SUBJECT: HOLTEC INTERNATIONAL'S APPLICATION FOR SPECIFIC INDEPENDENT SPENT FUEL STORAGE INSTALLATION LICENSE FOR THE HI-STORE CONSOLIDATED INTERIM STORAGE FACILITY FOR SPENT NUCLEAR FUEL – SECOND REQUEST FOR ADDITIONAL INFORMATION

Second Request for Additional Information

Application for specific independent spent fuel storage installation license for the HI-STORE Consolidated Interim Storage (CIS) Facility in Lea County, New Mexico

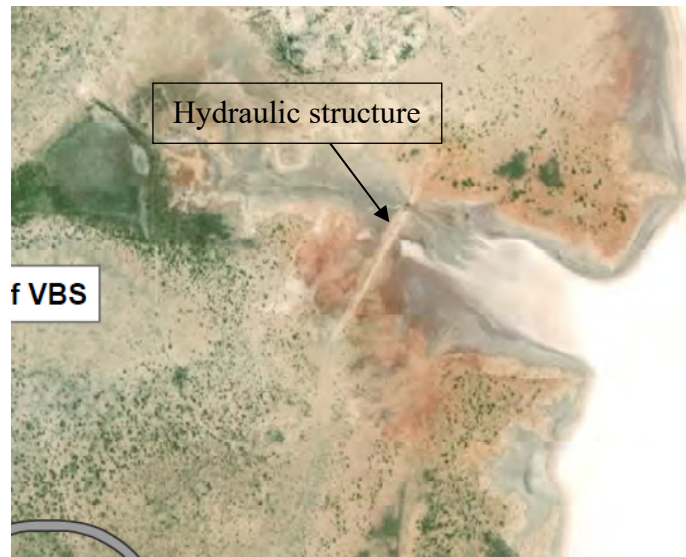
RAI 2-20-S: Provide an estimate of the likelihood that flooding may occur from a 100-year storm event as a result of damage to the hydraulic structure near Laguna Gatuna.

In its response to RAI 2-20, the applicant provided a PMP/PMF study (GEI, 2019), which assumes Laguna Gatuna in 'extreme full' condition, with water inundating the hydraulic structure. The effect of the hydraulic structure on flooding is thus accounted for. However, in the 100-yr storm event, where the Laguna was assumed to be filled with 5 feet deep of water,

runoff into the wash and the hydraulic structure (looking like an earthen dam with an area that has been broken – see picture taken from the GEI report, Fig. 6) may create back water effect, which in turn may cause flooding around the northeastern corner of the proposed CISF. Provide calculations to estimate the likelihood that flooding may occur and, if so, at what depth under this scenario.

Alternatively, most of the water in Laguna Gatuna will be stored east of this structure in a sub-PMP storm event. Provide additional analyses to determine the potential impact of the structure's partial or complete collapse (e.g., the potential for flooding to the wash northeast of the proposed CISF), particularly under sub-PMP weather conditions.
